MX0020A-01

# Modification Recommended Service Note

## InfiniiMax Ultra 10 GHz Probe Amp with AutoProbe 2 Interface

Figure 1.

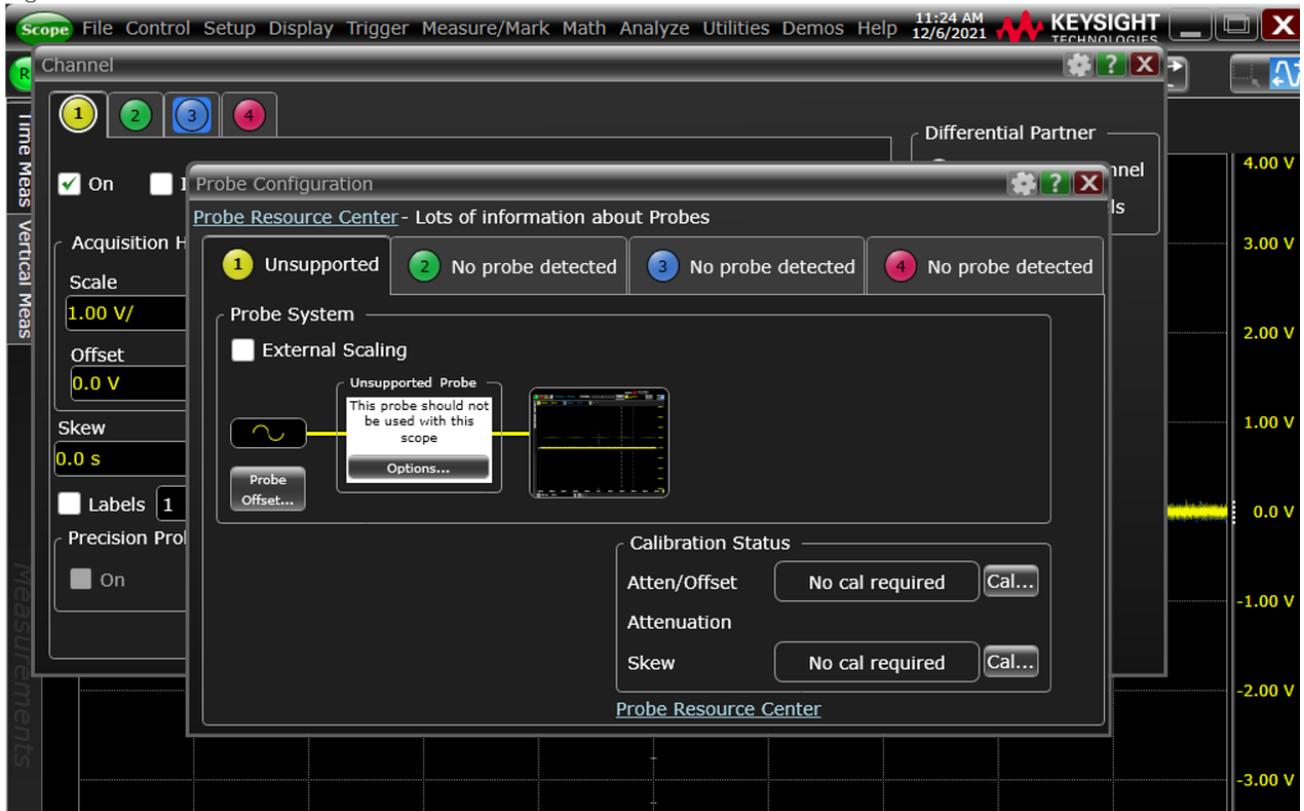
The early shipments of MX0020A probes have a quality concern that can cause probes to not be recognized when attached to the scope channel. Please see Figure 1.

- 1. Capacitor failure

Please return defective probe amplifier to service center for repair.
